**ADDENDUM NO. 01**  
**ALEXANDER II ROOF PROJECT**

PROJECT NUMBER: 16BBEJ06RF081  
BIBB COUNTY SCHOOL DISTRICT

RFP NUMBER 17-6

DATE OF ISSUE: 21 SEP 2016

## COST PROPOSAL

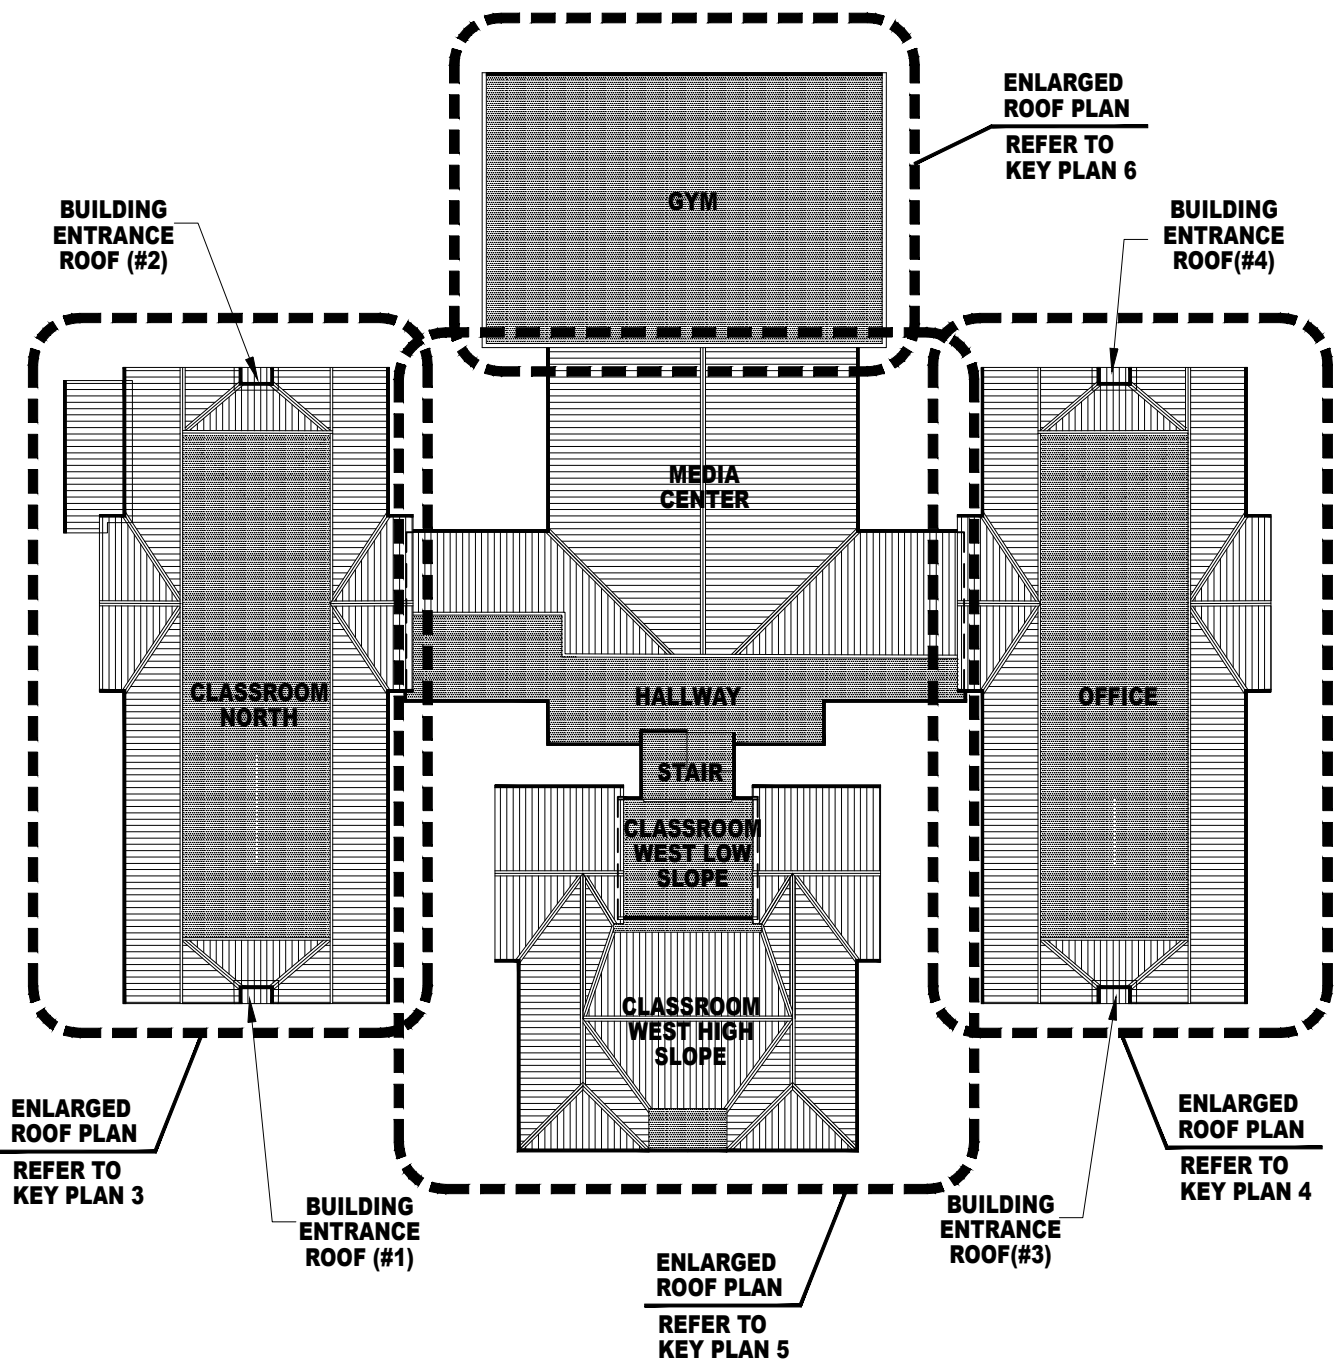
1. Replace a page from the original Cost Proposal in Appendix A of the RFP Packet with the attached page, which adds alternate nine.
2. Replace the original diagram package with the attached diagram package.
3. The address of Alexander II school is 1156 College Street Macon, GA, 31201. Ignore any other address in the project documents for the physical location of this facility.

This page revised by addendum No 1
